Cree® High Brightness SMD LED Product Change Notification

PCN Reference Number: CREE-PCN-0998

Date Issued: April 1, 2020

2. Cover-tape ESD adhesive tape
Current (ESD qualified material)

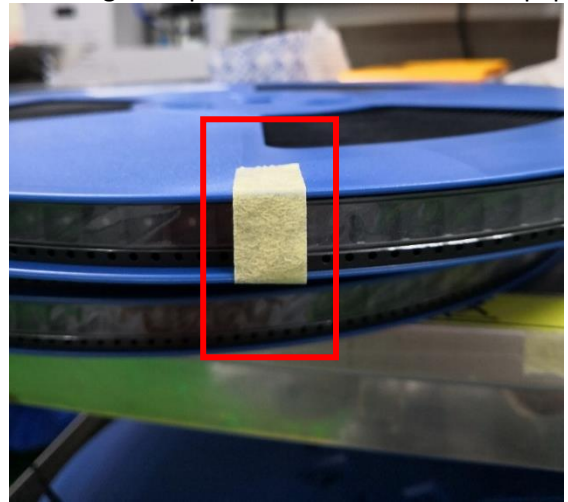
The tape leader and trailer quantities for HB SMD LEDs have been standardized. HB SMD LEDs change back to use yellow ESD adhesive tape to attach the cover-tape leader to the reel.

New (Yellow high-temperature-resistant adhesive paper)

a. 7" reel packaging

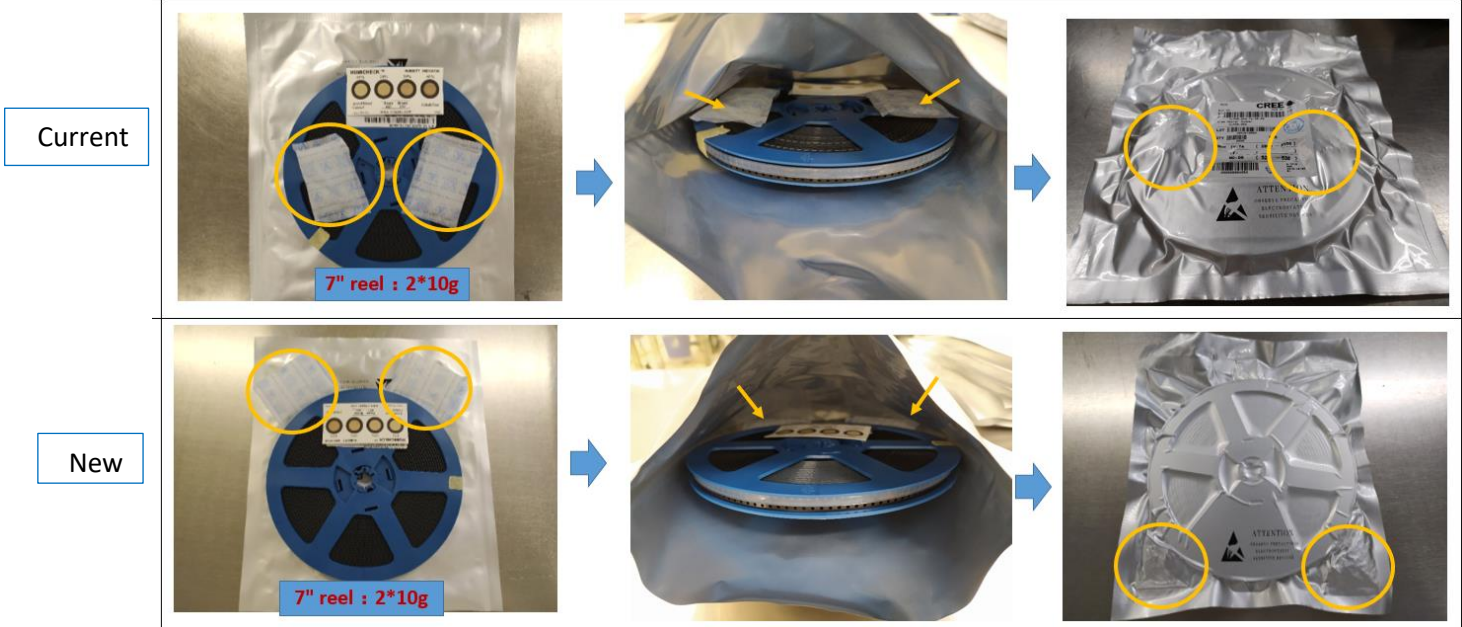
The current SMD LED packaging with five 10-g desiccant bags has been revised to use two 20-g desiccant bags and the placement of the desiccant bags in the polyethylene bag has been adjusted.

3. Adjust the desiccant bag quantity and placement
